March 10, 1975

Subject: Dresden Station Environmental
 Technical Specification
 NRC Dkts. 50-237 and 50-249

Subject: Response to NRC Requests (dated Feb. 4, 1975)
re. Dresden Environmental Technical Specifications

Fig. A1. - Surface isotherms of normalized temperature rise $\frac{\Delta T}{\Delta T_D}$ for mixed-discharge mode,
 $Q_{ILL} = 6900$ cfs.

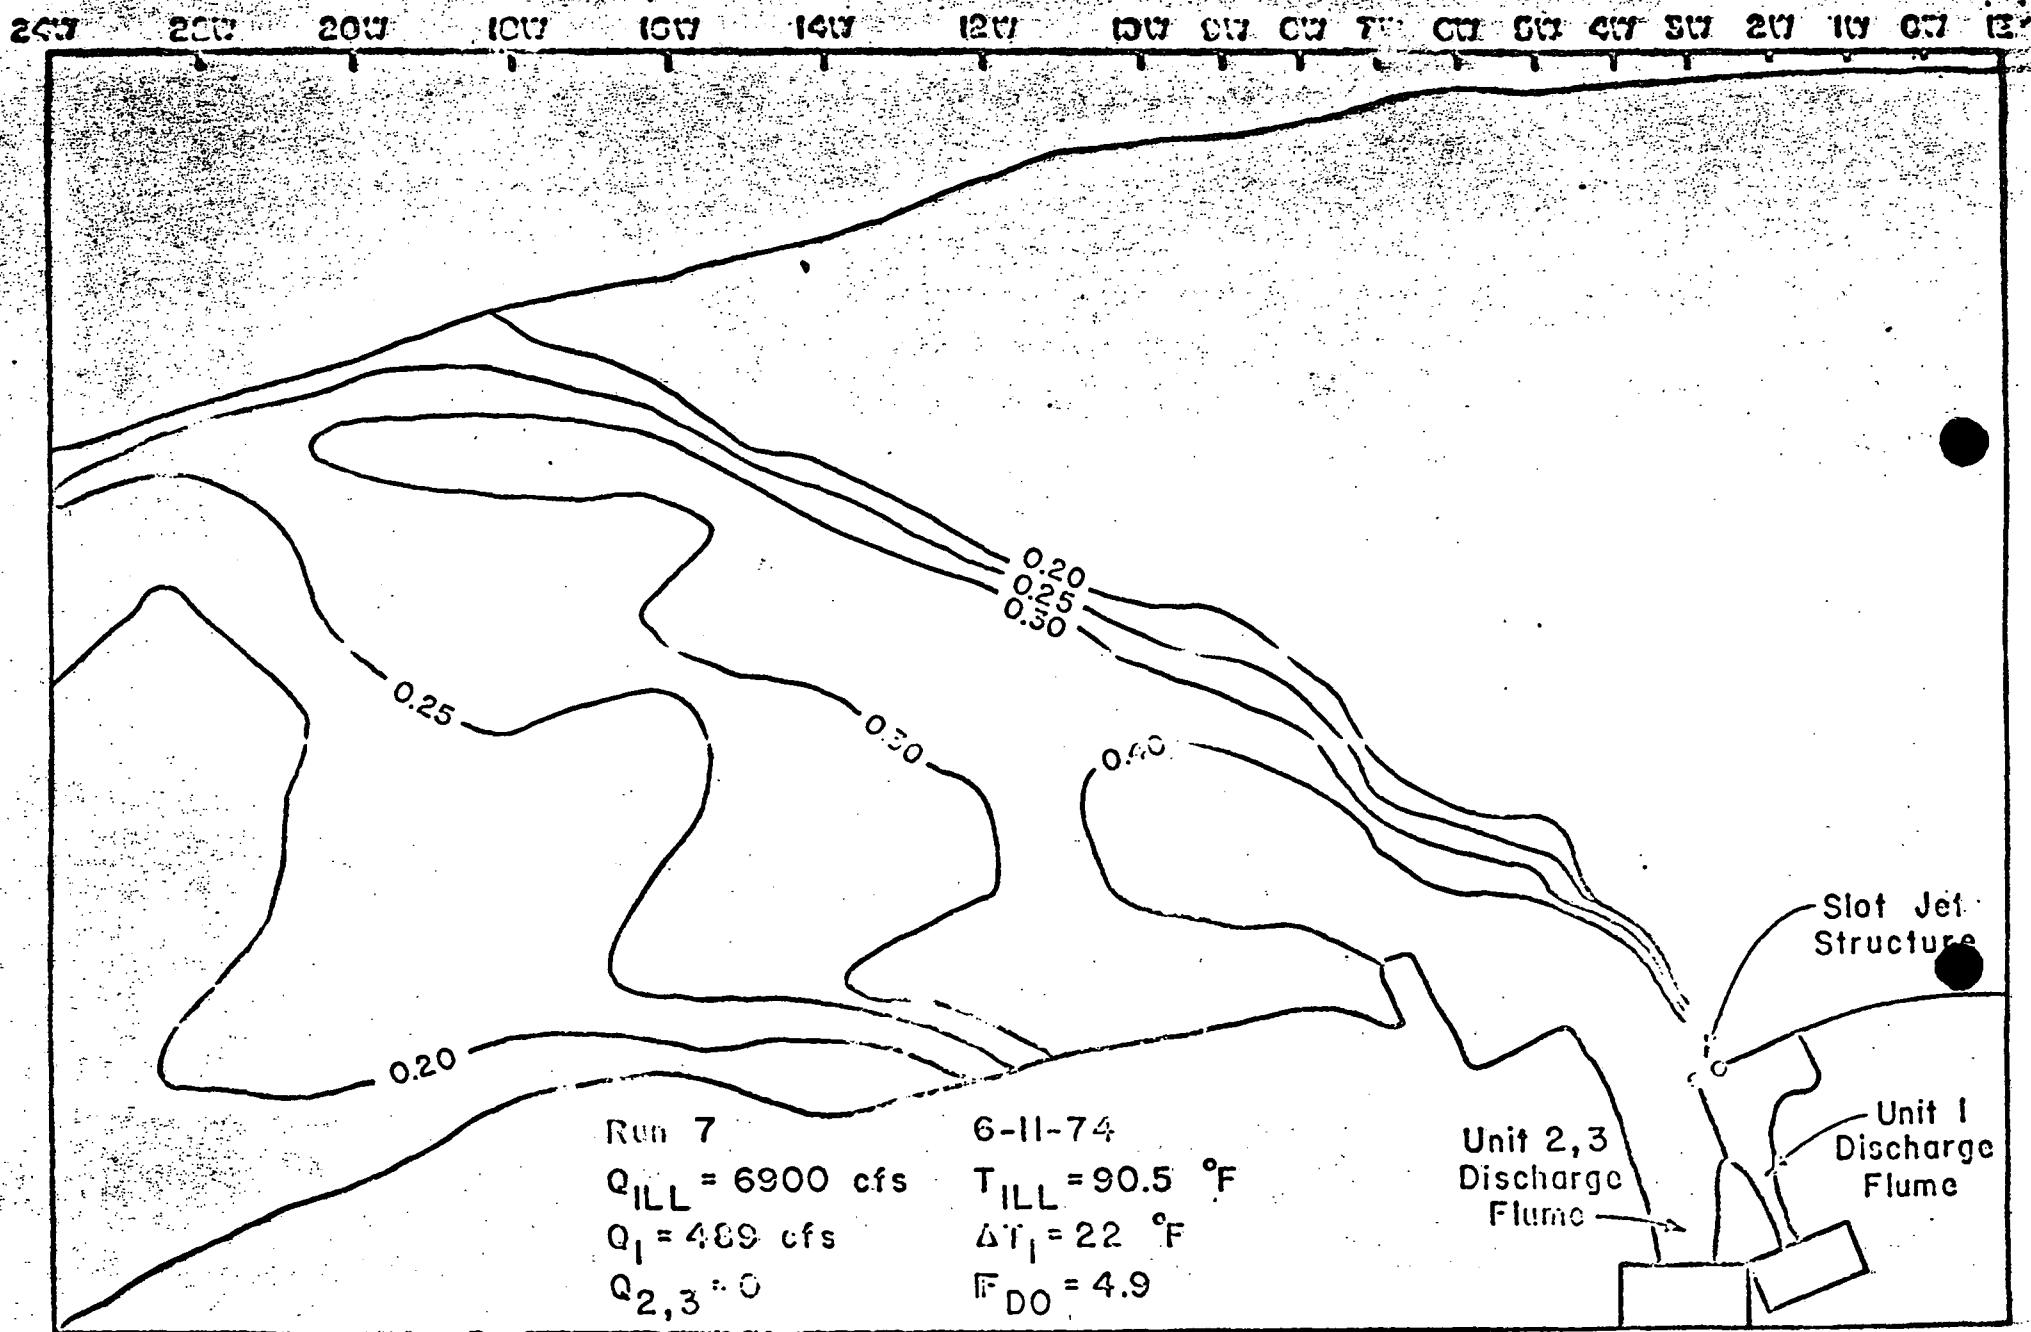
A typical set of surface isotherms of the normalized temperature rise $\Delta T/\Delta T_D$, observed in the model, is shown in Fig. A1. Values of $\Delta T_{26}/\Delta T_D$ for constructing the compliance-test diagrams were obtained from the surface isotherm data by planimetering the areas enclosed by the different isotherms and plotting the $\Delta T/\Delta T_D$ values against the enclosed areas in acres. The point at which the curve connecting the points crosses the line $A = 26$ acres defines the value of $\Delta T_{26}/\Delta T_D$.

Fig. A2. - Laboratory data for mixed-discharge mode compliance-test diagram.

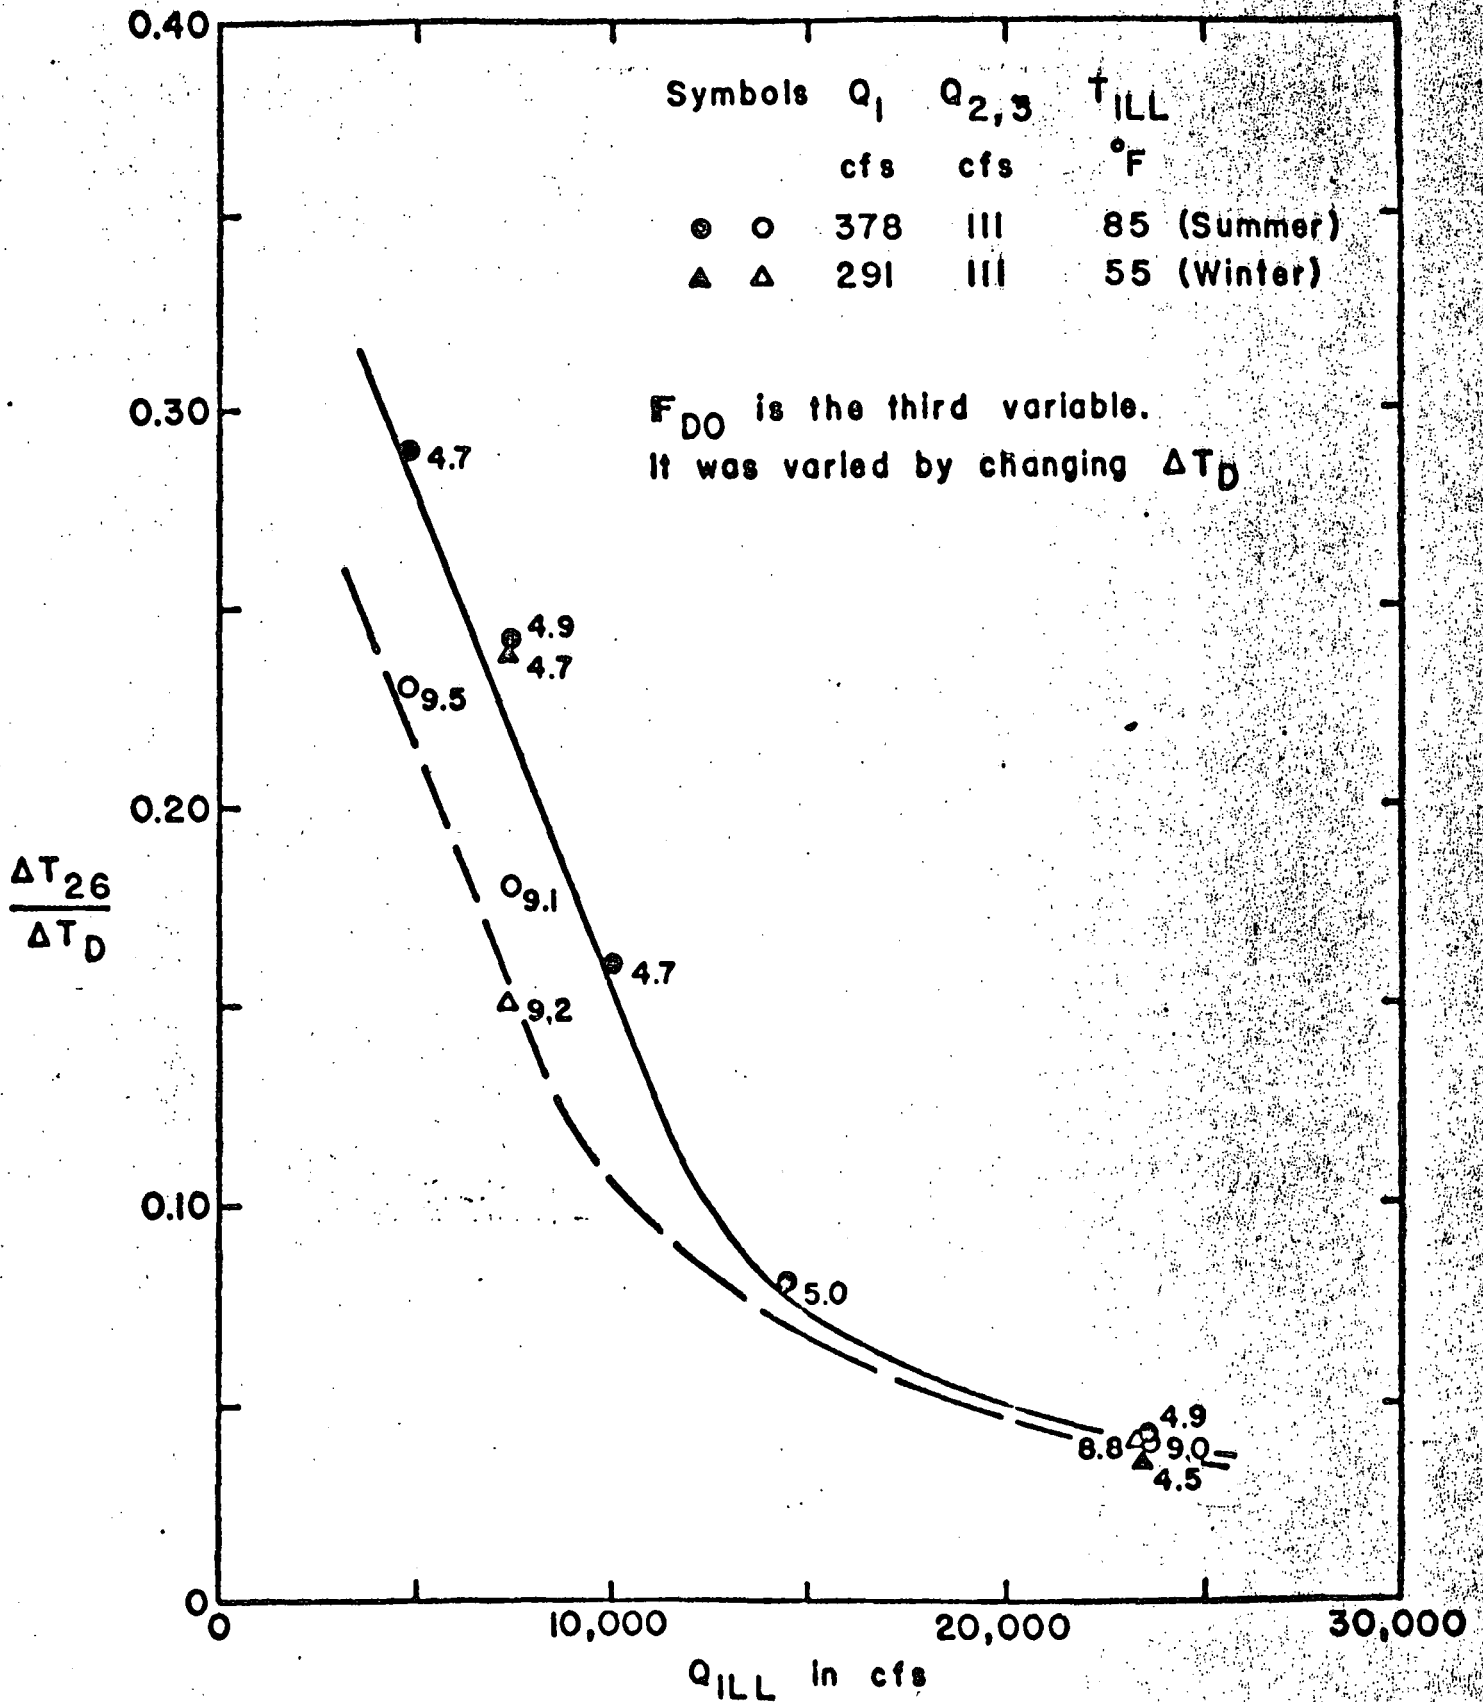
To construct the compliance-test diagrams the resulting values of $\Delta T_{26}/\Delta T_D$ were plotted against Q_{ILL} as shown in Fig. A2 for the mixed-discharge operating mode. Two curves are shown in Fig. A2. The solid curve simulates full plant load with $\Delta T_{D1} = 19^\circ\text{F}$, $\Delta T_{D2,3} = 28^\circ\text{F}$, $\Delta T_{I1} = 0$, $T_{ILL} = 85^\circ\text{F}$ for summer, and $T_{ILL} = 55^\circ\text{F}$ for the months when the ice-melting system is in operation. For these conditions $F_{DO} \approx 5$ in the model (10 in the prototype). Any reduction in ΔT_{D1} , $\Delta T_{D2,3}$, or T_{ILL} , either individually or collectively,

would increase the value of F_{DO} , consequently reducing the tendency for vertical temperature stratification to occur, which in turn would reduce the value of $\Delta T_{26}/\Delta T_D$. This tendency is verified in the dashed curve for which F_{DO} was increased to about 10 in the model (20 in the prototype) by reducing the values of ΔT_{D1} and $\Delta T_{D2,3}$. Note that each of the curves represents both summer and winter conditions. Apparently the reductions in Q_1 and T_{ILL} for the winter conditions have mutually offsetting effects.

Due to the tendency of the distorted model to accentuate stratification effects, it is quite possible that the dashed curve simulates full load conditions in the prototype better than the solid curve. However, the conservative approach was followed in adopting the solid curve for use in the provisional compliance-test diagram in Fig. 3.

Fig. A3. - Laboratory data for unmixed-discharge mode compliance-test diagram.

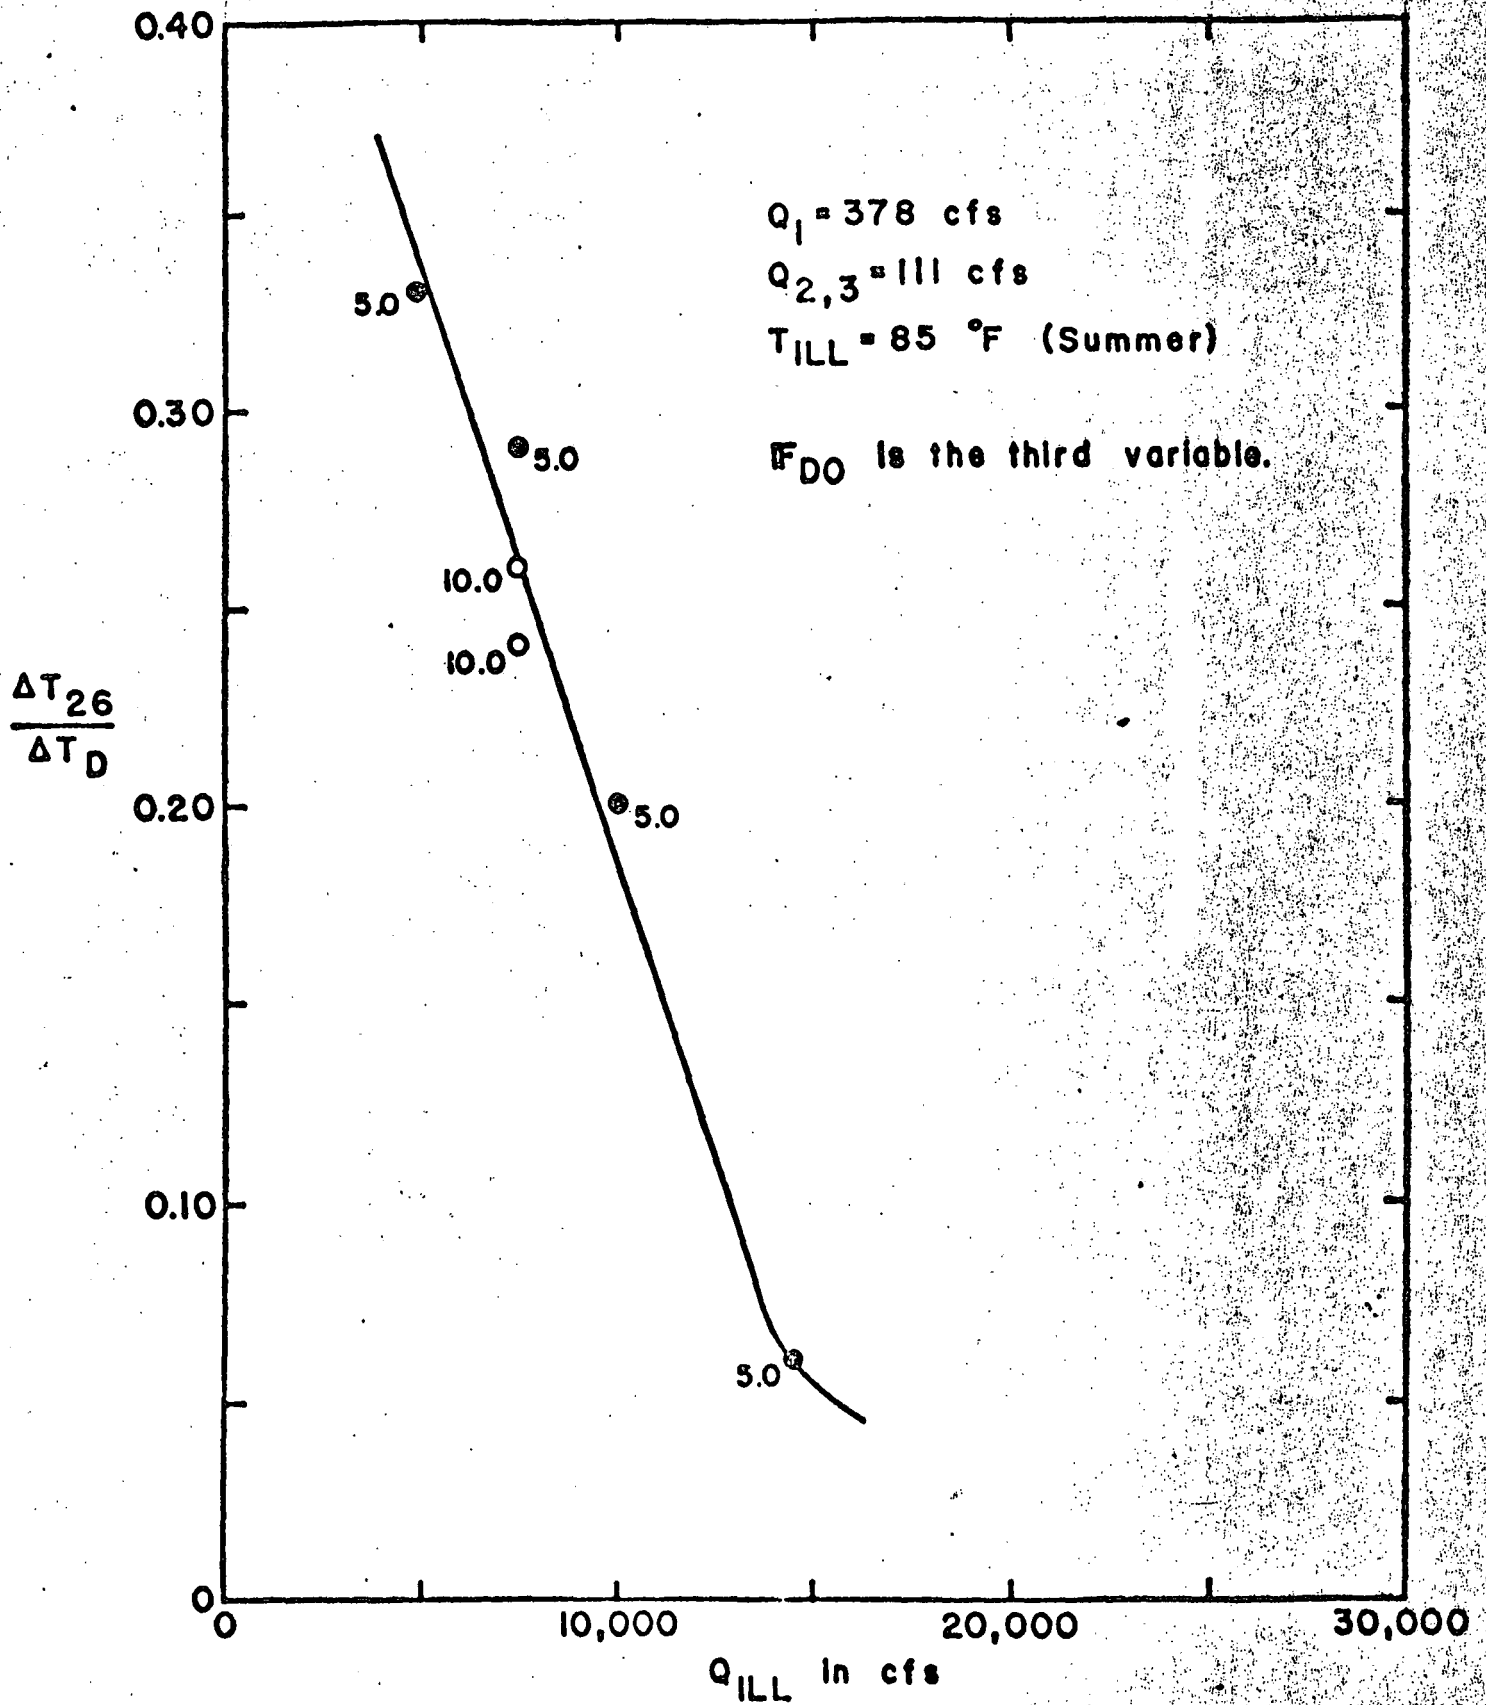
Fig. A3 shows the laboratory data used in constructing the compliance-test diagram for the unmixed-discharge operating mode. Only the summertime conditions were simulated in the laboratory. The third variable F_{DO} is in this case a hybrid initial jet densimetric Froude number wherein U_0 = initial velocity of the Unit 1 discharge through the slot, and $\Delta \rho_0$ = density difference based on the ambient temperature T_{ILL} and the temperature of the combined heated discharges T_D . Two data points are shown for which $F_{DO} = 10$. For the upper one, F_{DO} was increased by halving the slot width and doubling U_0 . For the lower one, F_{DO} was increased by reducing ΔT_D . It apparently makes little difference which way F_{DO} is increased. In comparison with Fig. A2, there seems to be relatively little sensitivity to F_{DO} in Fig. A3. This result was somewhat unexpected.

DRESDEN STATION THERMAL PLUME
 DATE: 8-10-74 TIME 08:16-1005
 AREA THERMAL PLUME 0.35 SQ. MILES

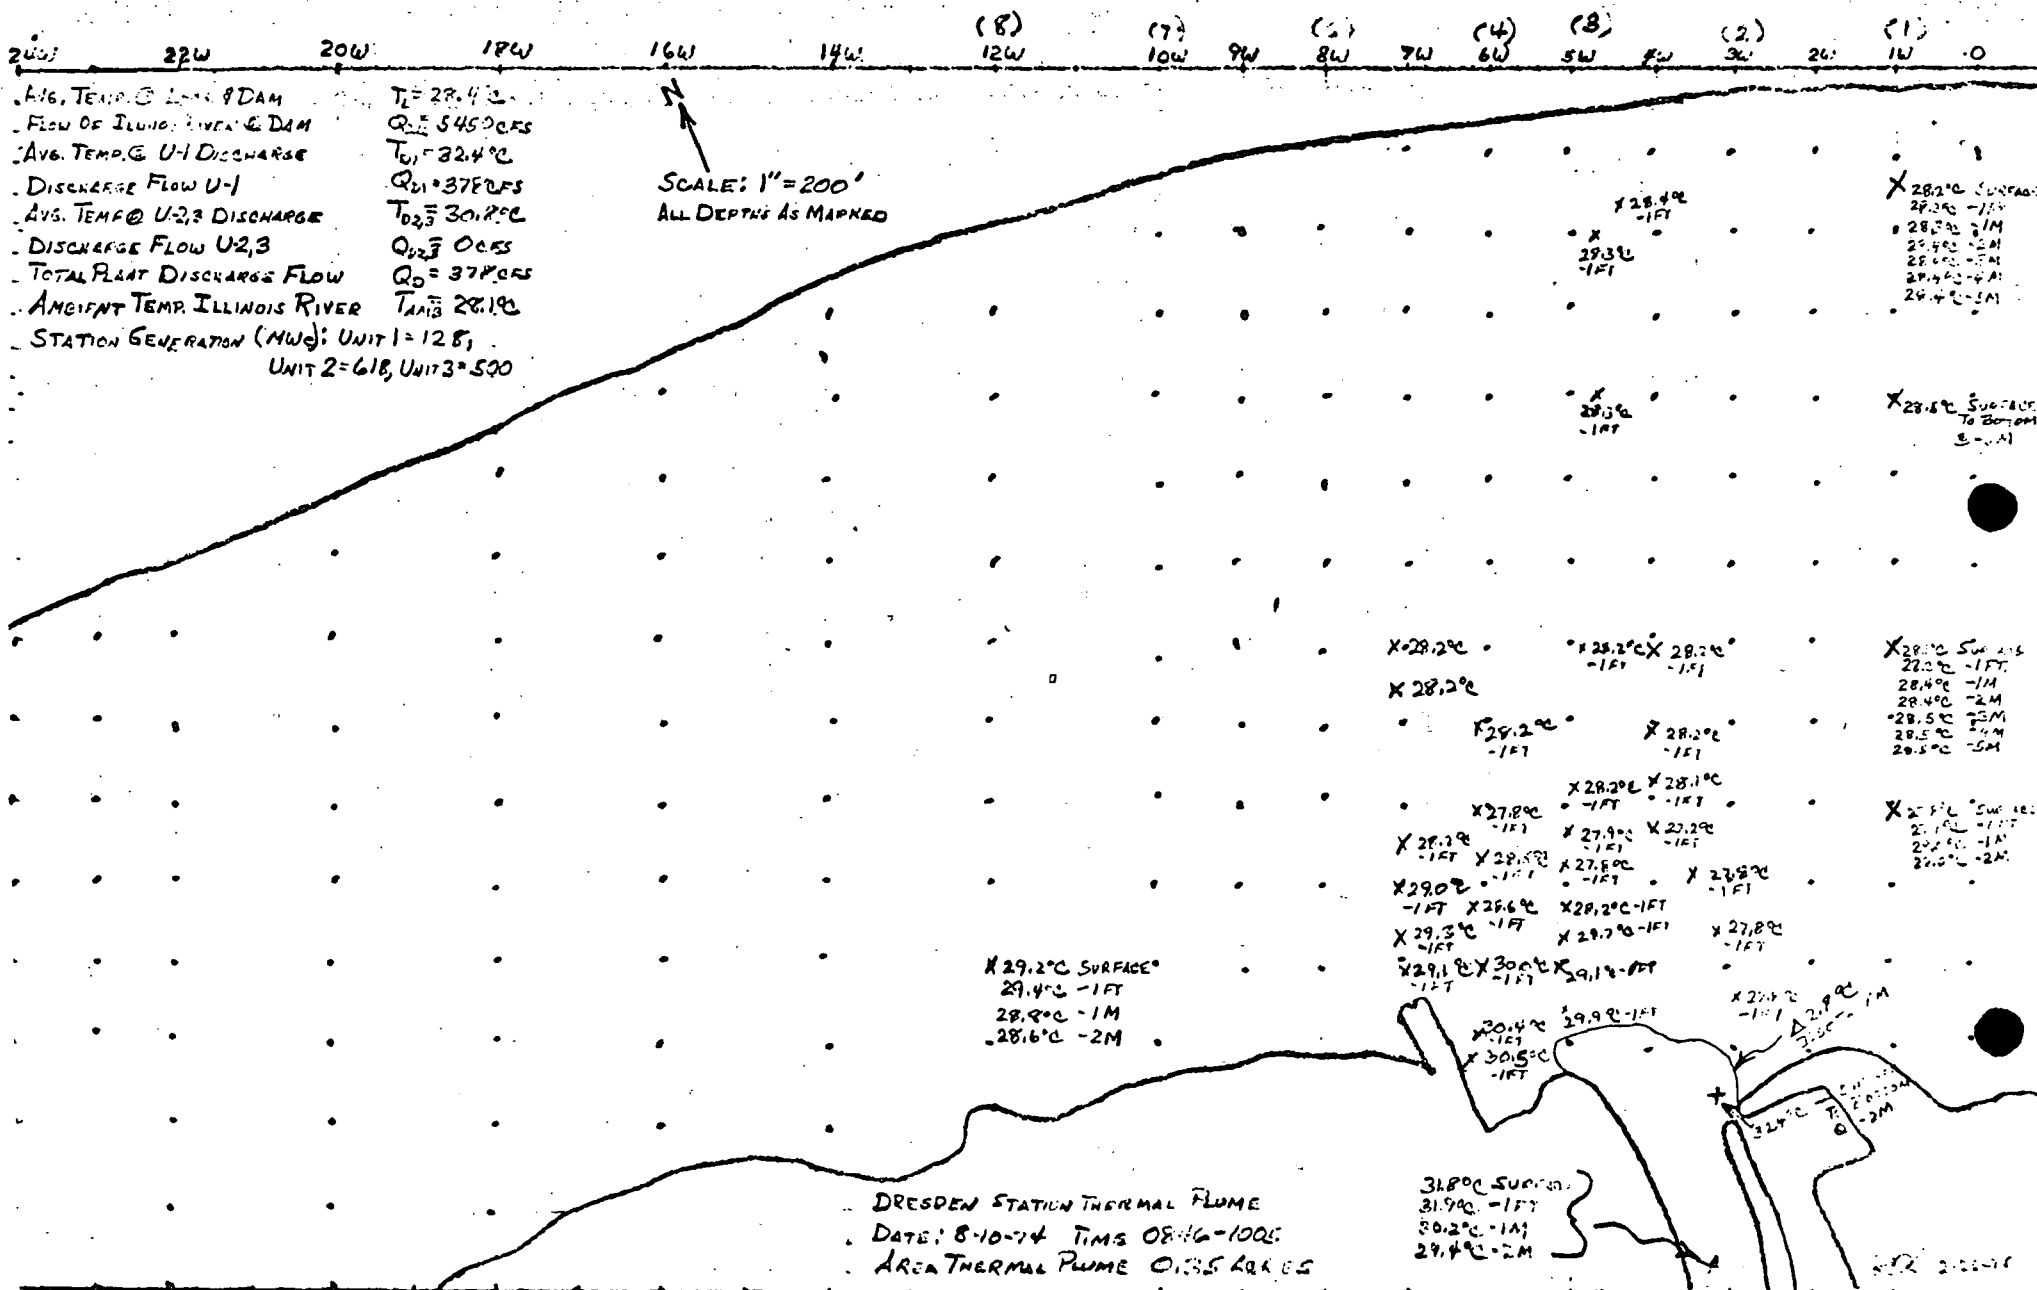
Study of August 10, 1974 (morning):

The plant load was 1246 MWe (Unit 1=75, Unit 2=650, Unit 3=500). Flow from the Unit 1 discharge canal was 378 cfs. Unit 2/3 discharge was zero. Flow in the river was about 5,450 cfs and the ambient water temperature was 28.1°C. The area contained within the excess 2.8°C isoline was 0.35 acres.
